AEP:NRC:3691-05
10 CFR 50.4

Donald C. Cook Nuclear Plant Units 1 and 2
STEAM GENERATOR INSPECTION – REQUEST FOR ADDITIONAL
INFORMATION (TAC NOS. MB8121 and MB8122)

Steam Generator Inspections Request for Additional Information

Figure 1
Unit 1 Steam Generator

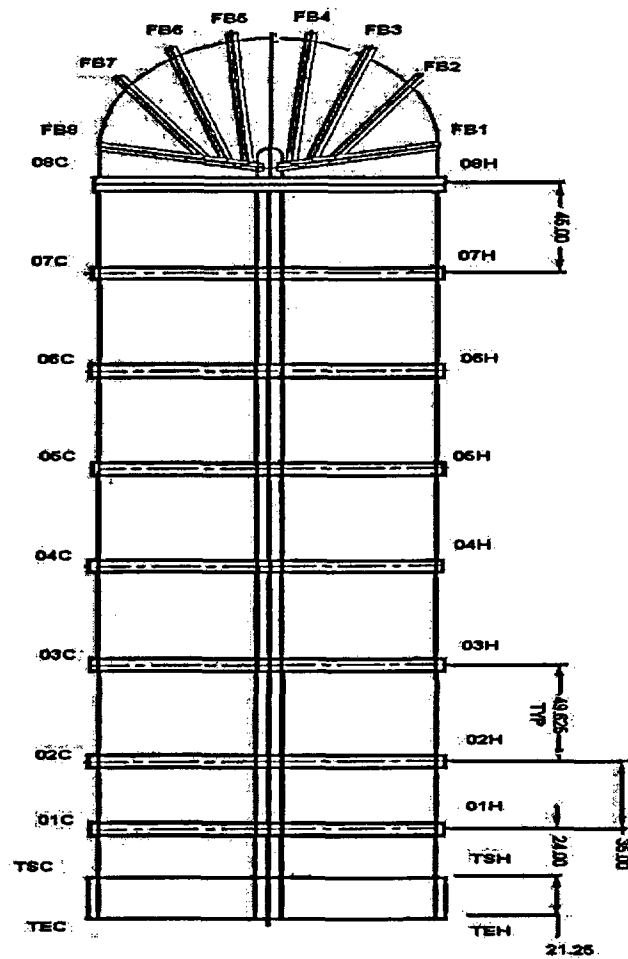
In several locations in your reports, reference is made to tube support structures (e.g., fan bar 5) and tube locations (e.g., R53/C53). In order for the staff to better understand the location of the indications and the tubes, please provide (1) sketches of the Unit 1 and 2 steam generators that depict the tube support naming conventions and (2) tubesheet maps that depict the rows and columns of the tubes. In addition, please provide a general description of the replacement steam generators for both Units 1 and 2. Include in this general description the total number of tubes, tube diameter, tube wall thickness, tube material, tube pitch, tube support (including fan bar/anti-vibration bar) material and configuration (e.g., quatrefoil broached hole), tube support thickness, tube manufacturer, steam generator manufacturer, tubesheet expansion method (e.g., hydraulic) and any other noteworthy design characteristics from a steam generator tube integrity standpoint (e.g., full length stress relief of the row 1 through row 10 tubes). In addition, discuss whether measurements from a tube support are from the middle of the support or the edge of the support (e.g., does fan bar 5 plus 0.61 inches, indicate an indication 0.61 inches from the top edge of the fan bar).

Schematics of the Unit 1 and Unit 2 steam generators are provided in Figures 1 and 3, respectively. Diagrams of the Unit 1 and Unit 2 tubesheets are provided in Figures 2 and 4, respectively. Table 1 provides the details of the Unit 1 steam generator, and Table 2 provides the details of the Unit 2 steam generator.

The convention for providing tube locations is to measure from the middle of the tube support. Thus, the location 05H + 0.50 is 0.50 inches above the middle of the fifth tube support on the tube hot leg side.

Figure 5
Unit 1 Bobbin Voltage Amplitude Distribution

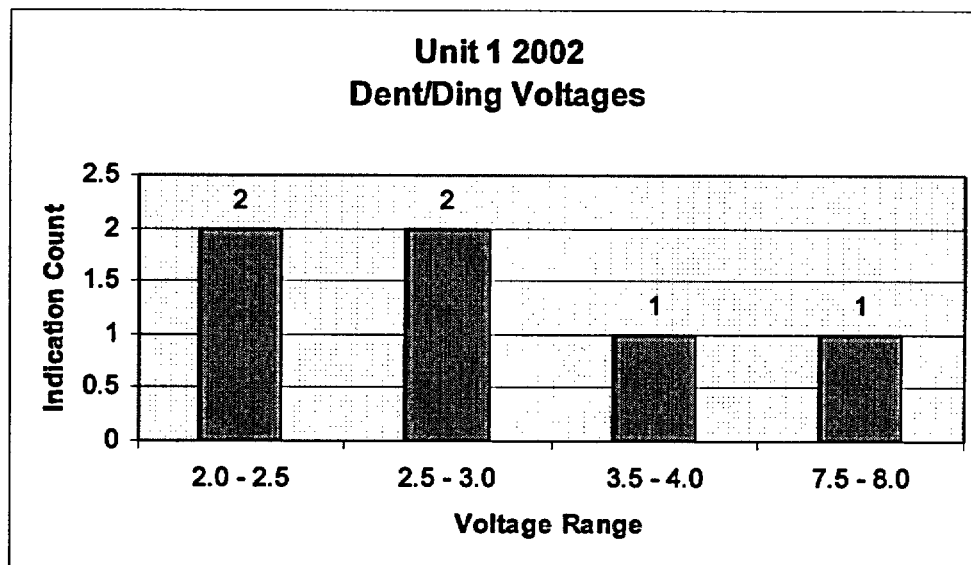
For both Units 1 and 2 there were a number of steam generator dents and dings reported. Please provide the bobbin voltage amplitudes for these dents and dings (a graph depicting the distribution of amplitudes is acceptable). In addition, discuss whether these dents/dings were present since the baseline inspection. If the dents/dings were not present since the baseline inspection, discuss the possible root cause. For Unit 1, only one of the 6 dents/dings was examined by a rotating probe. Please discuss the basis for selecting this one indication for rotating probe testing. For Unit 2, 20 percent of the dents/dings were tested with a rotating probe. Please discuss how the 20 percent sample was selected (e.g., random, all indications above 5 volts with a random sample below 5 volts, etc.). Please discuss whether the method used to size the dents/dings is consistent with standard industry practice (alternatively provide a summary of the calibration method).

The bobbin voltage amplitude distributions for the dent/ding signals reported during the 2002 inspection are presented in Figure 5.

A review of the Unit 1 data noted that of the six indications, five were present in the baseline examination record and had not changed. The sixth tube, SG 14, R34/C26, was found to have a small ding indication (2.15 volts) in the U-bend region that was not present in the baseline data. This indication was most likely caused by either probe interaction when traversing the U-bend region or by steam generator movement during shipping (Note: The baseline examination was performed in the factory and no additional inspections were performed until 2002).

The planned 2002 Unit 1 rotating coil inspection for dents and dings consisted of a random 20 percent sample of all dent/ding indications above two volts. When the inspection results were obtained, it was noted that of the six dents/dings reported, five of the indications were in the U-bend area. However, due to an oversight, a U-bend rotating probe was not available to perform the one additional indication inspection necessary to comply with the 20 percent sample. A decision was made to inspect the accessible freespan indication and to defer the U-bend inspection of the one additional indication until the next scheduled inspection, the Unit 1, Cycle 19 refueling outage. This decision was judged to have no adverse impact on tube integrity due to the small signal amplitudes of the U-bend indications, the limited operating time of the Unit 1 steam generators, the enhanced design features and the degradation resistant properties and operating experience with the alloy 690 thermally treated tubing material. I&M plans to inspect a

Figure 7
Decision Flowchart

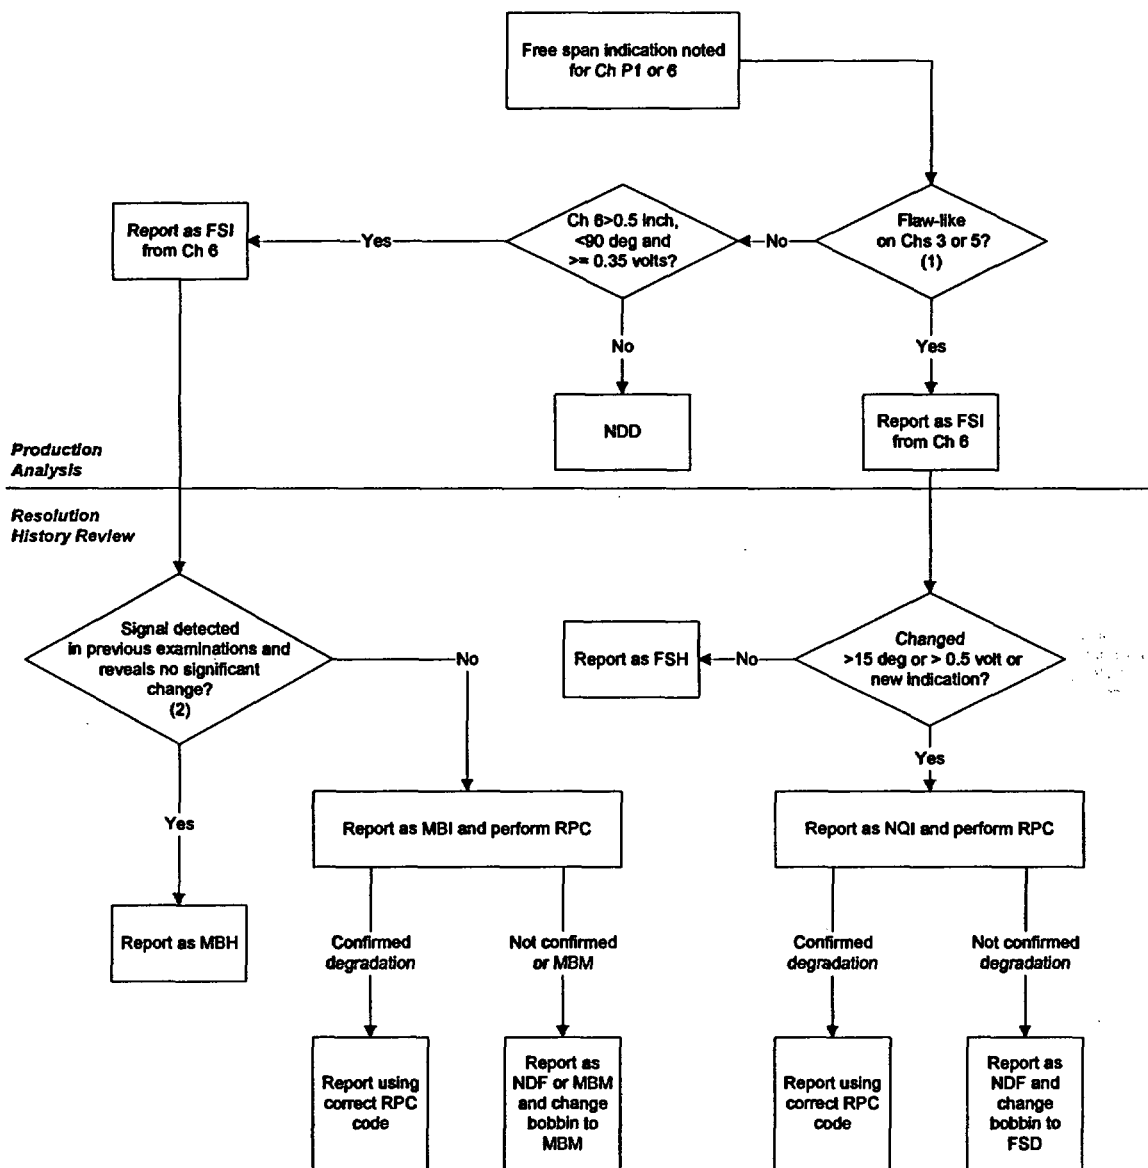
Four tubes in Unit 1 were plugged because of signal amplitude changes (1.0 to 2.5 volts) associated with MBMs/MBIs/MBHs. The MBIs were determined to have arisen from tube buffing operations during the manufacturing process after further investigation by EPRI. Although the indications may have been attributed to manufacturing, it is not clear why the signal amplitudes changed. Please provide a summary of your root cause analysis for why the indications changed in amplitude (or a description of what actions you may be planning to take to investigate the reason for the amplitude change). Please discuss whether any additional diagnostic testing was performed on these indications (e.g., ultrasonic testing, in-situ pressure testing, tube pulls, etc.). For the criteria used to determine if a manufacturing signal exhibits little or no change, discuss how the criteria was determined (e.g., was test repeatability evaluated for these types of indications such that the criteria would identify a signal change when the change was greater than normal test repeatability).

The criteria for determining whether a signal had changed was developed by the lead level III analyst and concurred with by an independent level III analyst. The criteria, which are based upon industry experience, are illustrated in Figure 7.

(1) Flaw-like: reads above 0%

(2) Significant change: >15 degree positive phase shift. All MBH calls require review by both resolution analysts.
